**PCN20240418001.1**  
**Qualification of additional Assembly sites for select VSSOP (MSOP) devices**  
**Change Notification / Sample Request**

<b>PCN Number:</b>	PCN#20240418001.1	<b>PCN Date:</b>	April 18, 2024
<b>Title:</b>	Qualification of additional Assembly sites for select VSSOP (MSOP) devices		
<b>Customer Contact:</b>	Change Management Team	<b>Dept:</b>	Quality Services
<b>Proposed 1<sup>st</sup> Ship Date:</b>	July 17, 2024	<b>Sample requests accepted until:</b>	May 18, 2024*

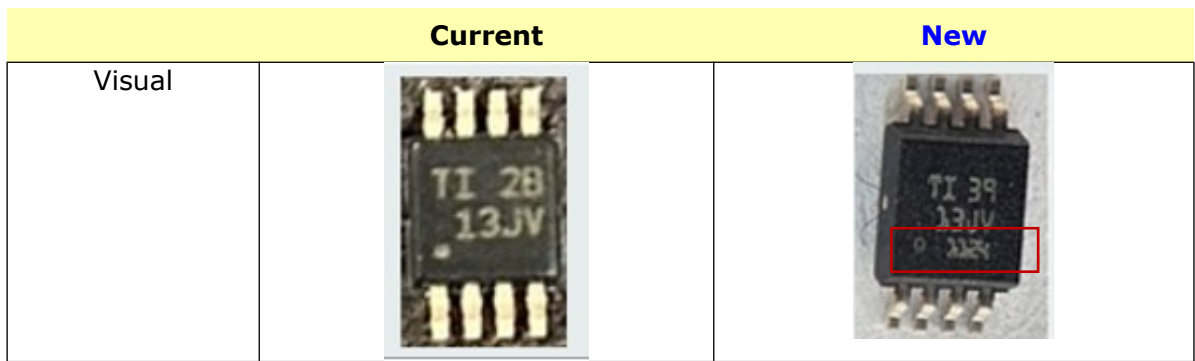
Additionally, the mold cavity id will be included in the top marking for these devices as follows:
